Application for Permission under Section 16 of the Town Planning Ordinance (Cap. 131) for Proposed Sewage Treatment Plant and Organic Waste Co-digestion Facilities at Government Land in D.D. 117, Yuen Long, New Territories

(Planning Application No. A/YL-TYST/1370)

Submission of Further Information

Responses to Comments – Departmental Comments (September 2026)

LOCATION OF REPRESENTATIVE
AIR SENSITIVE RECEIVERS
(CONSTRUCTION PHASE)

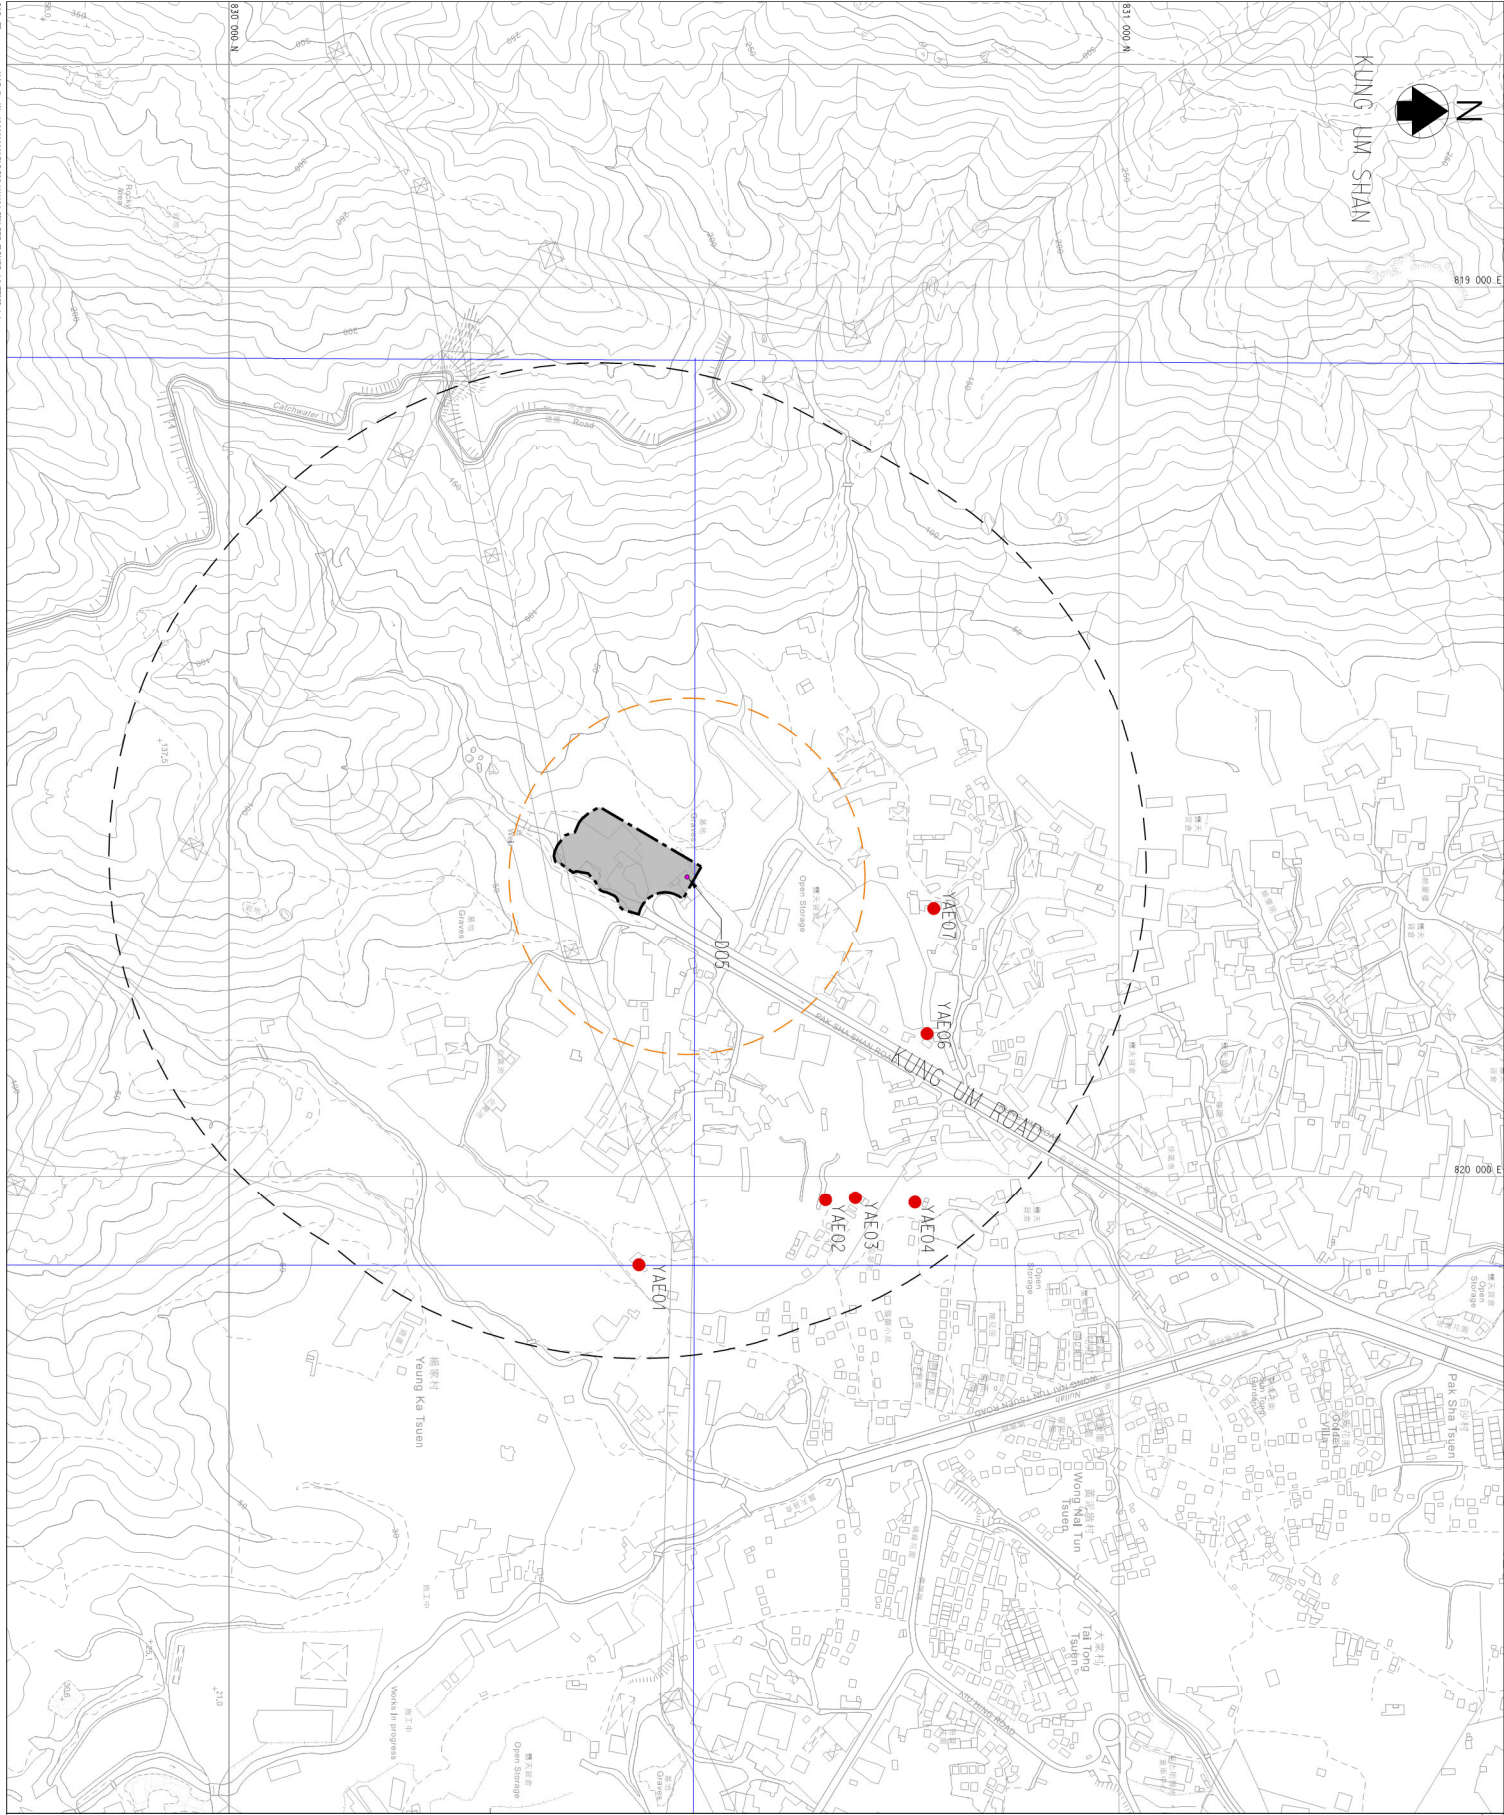
No.	Comments	Responses
	Comments <u>Water Quality</u> 1. Table 6.10 Please check the BOD5 data for NM6 and NM8 2. S6.3.5 Suggest to revise as “with the NH3-N WQO fully met.” <u>Air Quality</u> 3. Section 4.6.1 (a) Please revise “gaseous” in the 2nd last line to “air pollutant”. 4. Section 4.6.2 (a) Please add a sentence to state that there is only one odour emission source (DO5) in the Application Site after the 1st sentence. 5. Section 4.6.5 (a) Please add a sentence “The HKPSG should also be observed and followed to support the subject planning application.” at the beginning of this section. (b) Please add “Chapter 9 of” before “the HKPSG” in line 1. (c) Please revise “recommended to minimise potential odour nuisance” in line 2 to “should be required”. (d) Please supplement a figure to show the location of DO5 and its 200m buffer distance together with the ASRs to demonstrate that there is no ASR within the buffer zone.	Noted and updated. Please refer to Appendix A for replacement pages of the associated updated assessment report. Noted and updated. Please refer to Appendix A for replacement pages of the associated updated assessment report. Noted and updated. Please refer to Appendix A for replacement pages of the associated updated assessment report. Noted and supplemented. Please refer to Appendix A for replacement pages of the associated updated assessment report. Noted and supplemented. Please refer to Appendix A for replacement pages of the associated updated assessment report. Noted and updated. Please refer to Appendix A for replacement pages of the associated updated assessment report. Noted and added to Figure 4.2. Please refer to Appendix A for replacement pages of the associated updated assessment report.
